**CITY OF SUN VALLEY
PLANNING AND ZONING COMMISSION
AGENDA REPORT**

To: Planning and Zoning Commission
From: *MK* Mark Hofman, Community Development Director
Meeting Date: March 20, 2014
Agenda Item: **Warde Residence Addition
Design Review Application No. DR 2014-06**

SUBJECT: Public hearing for a design review application proposing the construction of a new 5,584 square foot residential addition and a 2,182 square foot buried accessory structure with related site and landscaping improvements on an existing developed lot within the Single Family Residential (RS-1) Zoning District of the City of Sun Valley. **Applicant:** Jolyon H. Sawrey for Tom Warde. **Application Filing Date:** February 7, 2014. **Location:** 100 Wedeln Lane; Lot 2A Prospector Knolls Subdivision.

DESIGN REVIEW SET

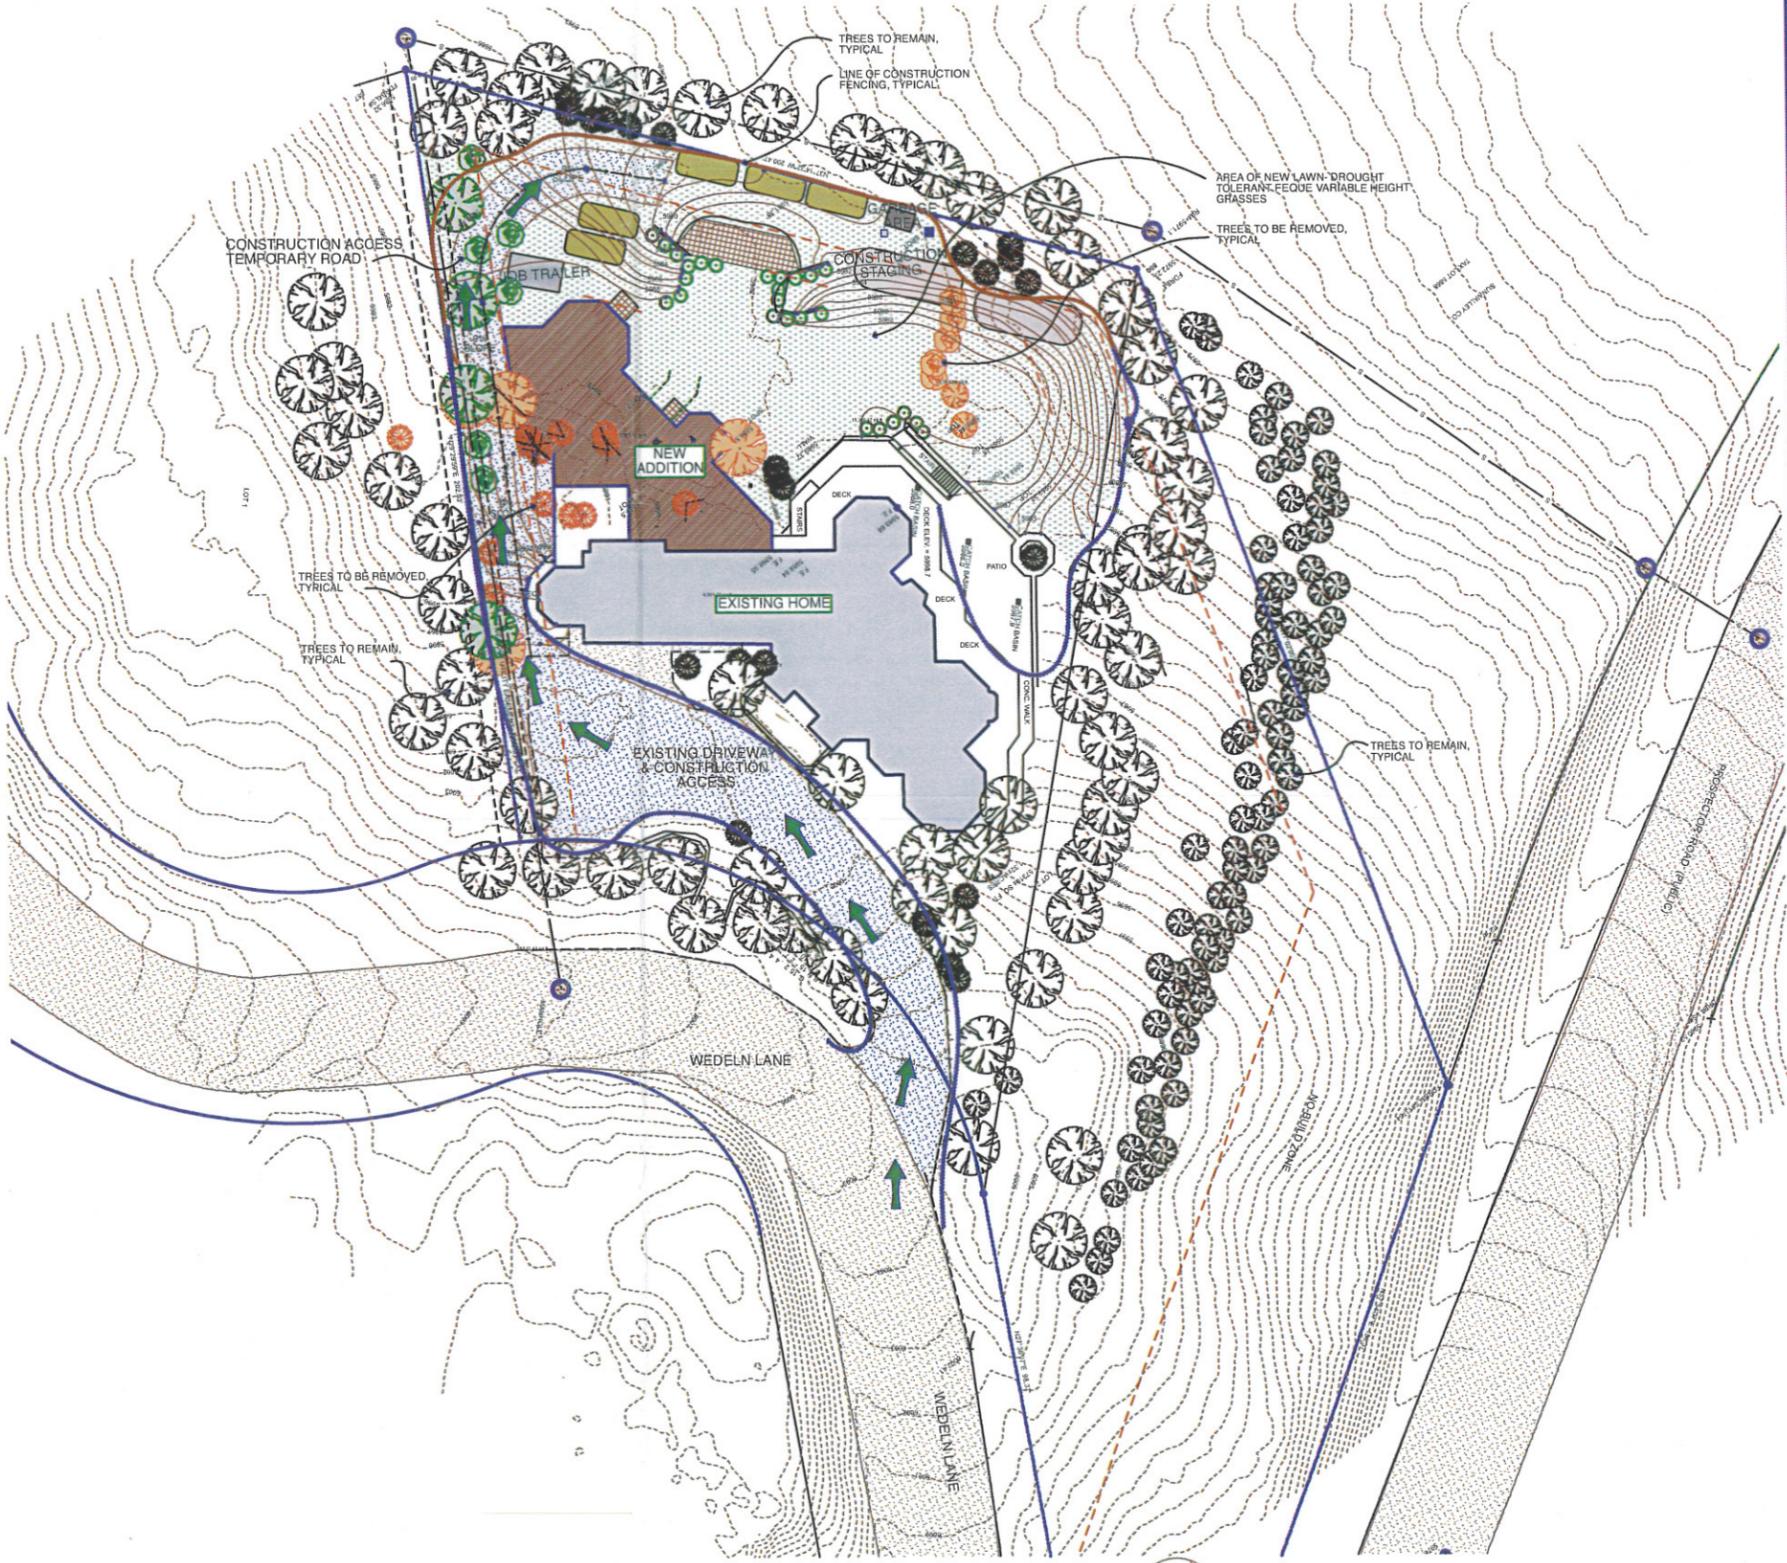
Construction Staging Access. The plan as originally submitted would be too steep and would require extensive grading for safe access to the site and for contractor parking.

The attached revised construction staging plan shows how construction access will be provided to the site if all access is to be provided entirely on the owners parcel. Parking for subcontractors will be managed by a shuttling system that will be created and the subcontractors parking at a City of Ketchum park and ride lot or other lots/ areas will be considered. Only a very few work trucks would be able to be onsite, supplies would be dropped off with trucks leaving and parking elsewhere offsite and not on adjacent public streets. No slope of the access road would exceed 10%. The contractor will maintain the road for run-off/erosion with sand/ gravel for slippery conditions and snow plowed
